SECTION 009113 – ADDENDUM TWO

- A. Project Name: 23087 Clinton Reroofing Project
- B. Owner: Clinton Public School District, 201 Easthaven Drive, Clinton, MS 39060.
- C. Architect: Dale | Bailey, an Association, One Jackson Place, Suite 250, 188 East Capitol Street, Jackson, MS 39201.
- D. Architect Project Number: 23087
- E. Date of Addendum Two: 21 February 2024

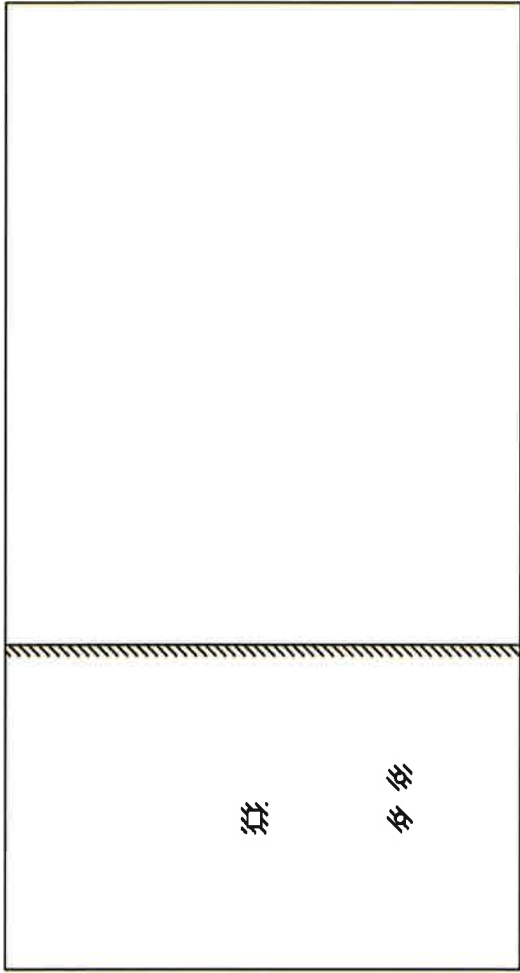
Remove all ACM roof wall and penetration flashing coating out 12 inches from the edge and down to the deck in the locations shown on attached drawing AS-1. Penetration include heater flues, plumbing vents, exhaust fans, etc. Coordinate work with roofing contractor so that replacement materials are installed same day as abatement of ACM roofing materials.
